Appl. No. 10/625,102
Amdt. dated Oct. __, 2005
Reply to Office Action of July 22, 2005

Amendments to the Drawings:

REMARKS/ARGUMENTS

Fig. 3A

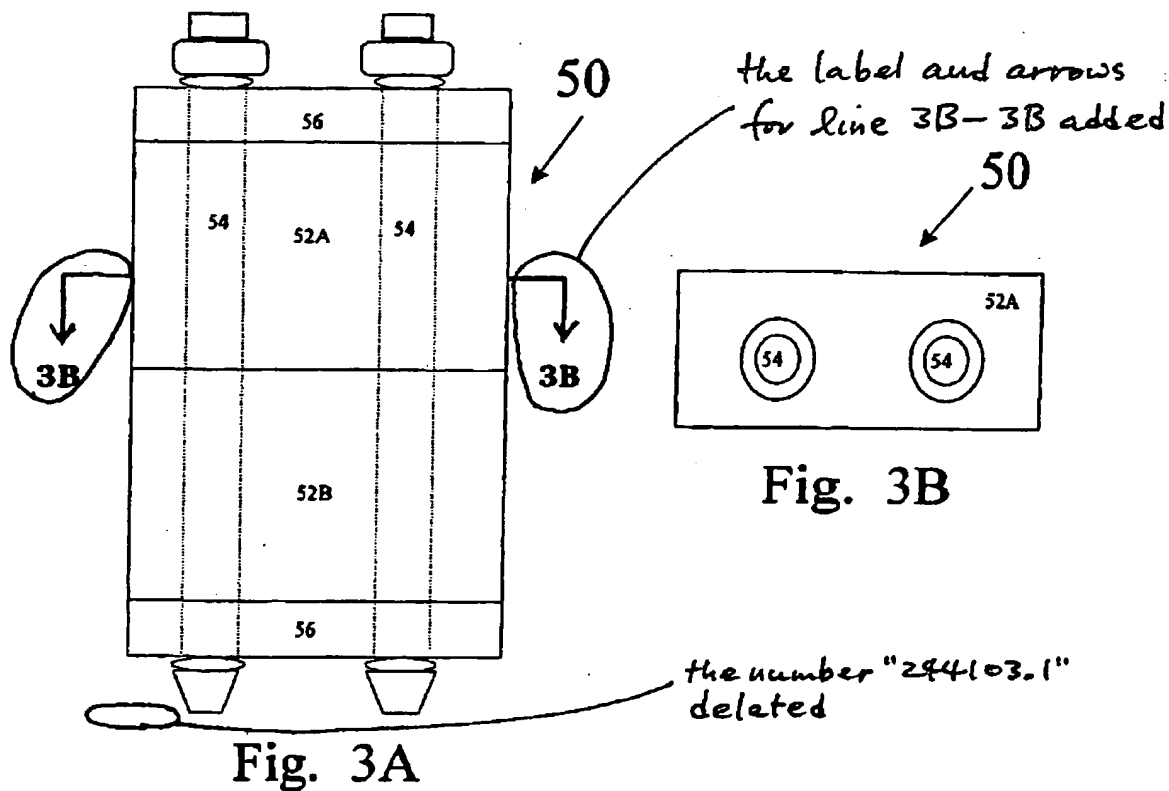
In amended FIG. 3A, the number "244103.T" at the bottom of the figure has been deleted, and appropriate labels and arrows for cross-sectioning line 3B-3B have been added.

In the July 22, 2005 Office Action, the Examiner requires that the number "244103.1" at the bottom of FIG. 3A and FIG. 5A be deleted. In response, Applicant respectfully submits replacement sheets, as well as an annotated marked-up copy showing change, for revised FIGS. 3A and 5A, in which the number "244103.1" at the bottom of these figures has been deleted.

The Examiner also requires that line 3B-3B, line 4B-4B and line 5B-5B be shown in FIGS. 3A, 4A and 5A, respectively, to show where the cross-sections for FIGS. 3B, 4B and 5B are coming from. In response, Applicant respectfully submits replacement sheets, as well as annotated marked-up copy showing change, for revised FIGS. 3A, 4A and 5A showing line 3B-3B, line 4B-4B and line 5B-5B, respectively.

Fig. 4B

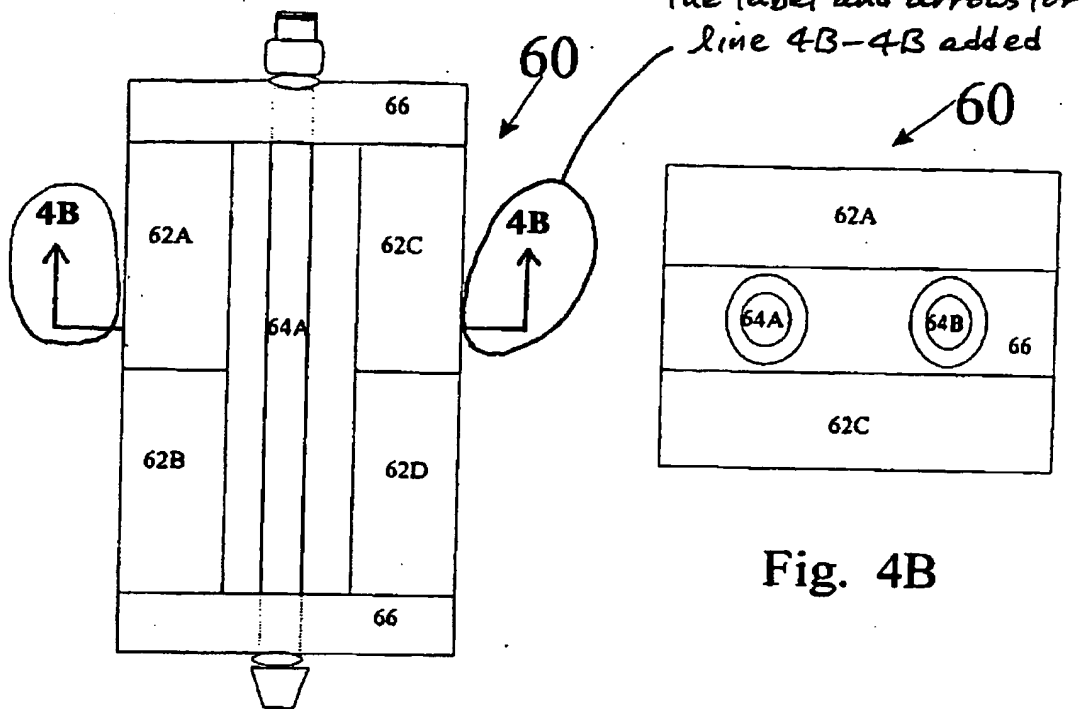
In amended FIG. 4A, appropriate labels and arrows for cross-sectioning line 4B-4B have been added.

Fig. 5A

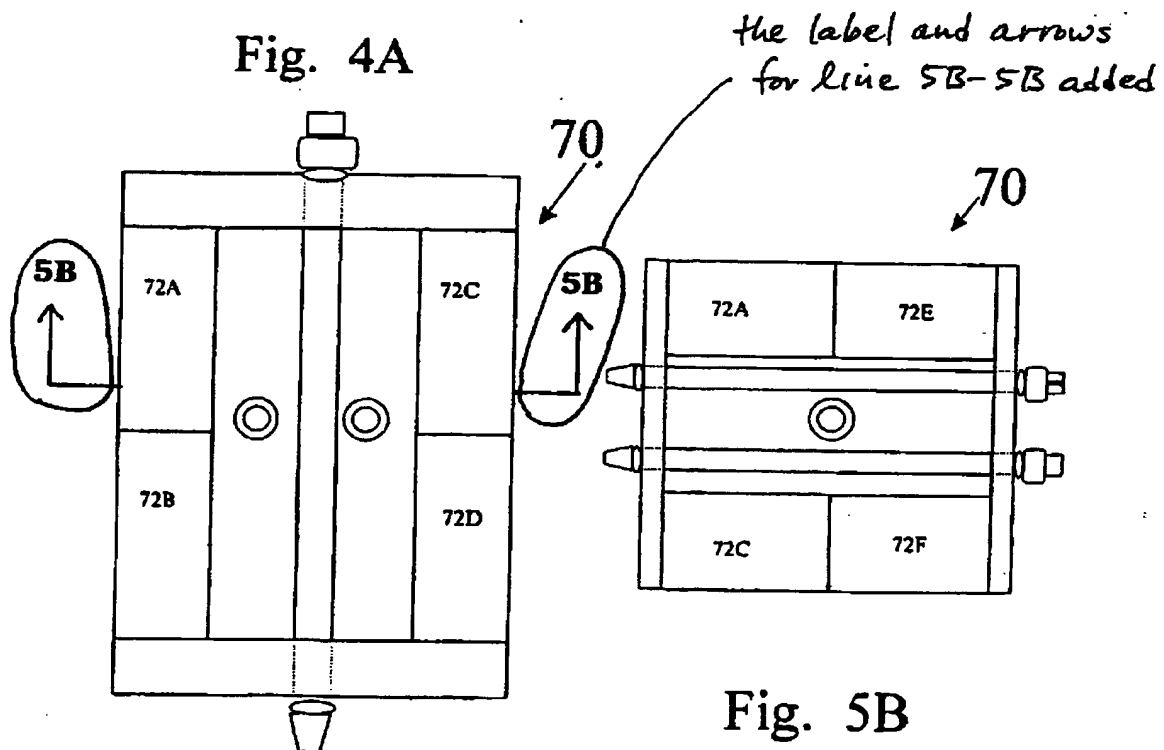
In amended FIG. 5A, the number "244103.T" at the bottom of the figure has been deleted, and appropriate labels and arrows for cross-sectioning line 5B-5B have been added.

the number "244103.1" deleted

Fig. 6

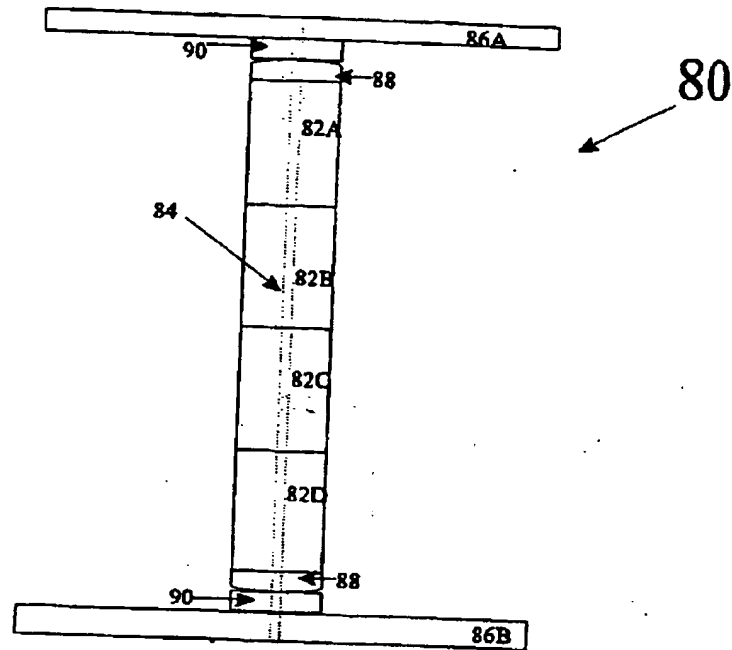
In addition, the Examiner objected to the drawings because reference numeral 88 shown in FIG. 6 does not appear to be described in the specification. In response, the Applicant has amended the paragraph [0057] of the specification to add in the description the reference numeral 88 shown in FIG. 6, which was inadvertently omitted previously. In view of the statement at the end of the paragraph [0057] that "this embodiment can be further modified in accordance with the teachings and principles discussed above with respect to embodiments 10, 10A, 50, 60 and 70," the amendment to this paragraph is supported by element 28 in FIG. 2 and the related text in the paragraph [0047].

Fig. 7

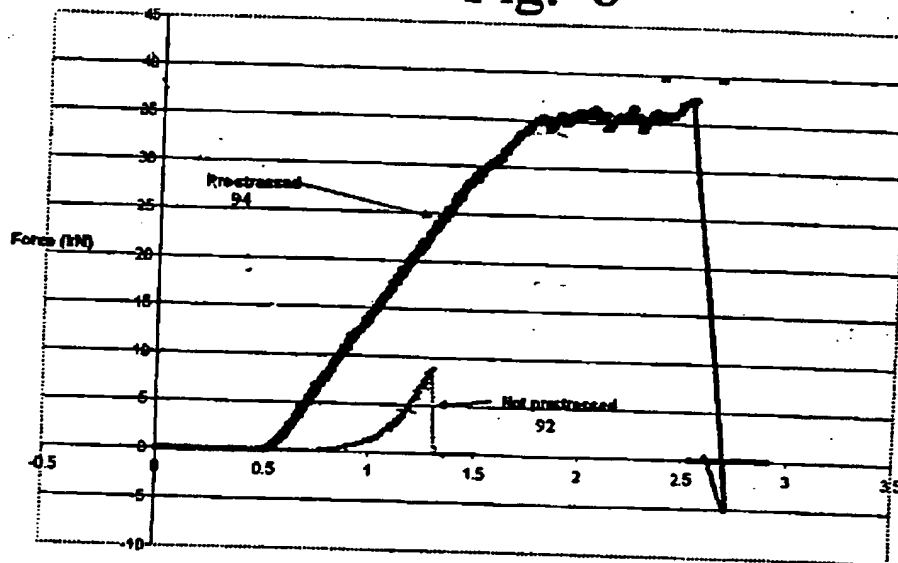
In amended FIG. 7, the unit for displacement in parentheses, (mm), has been deleted. It is respectfully submitted that, while the displacement values in FIG. 7 are indicative of the measure of strain, the numerical values for displacement are provided only for the purpose of comparison between the prestressed and non-prestressed results.

the unit for displacement,
 (mm), deleted
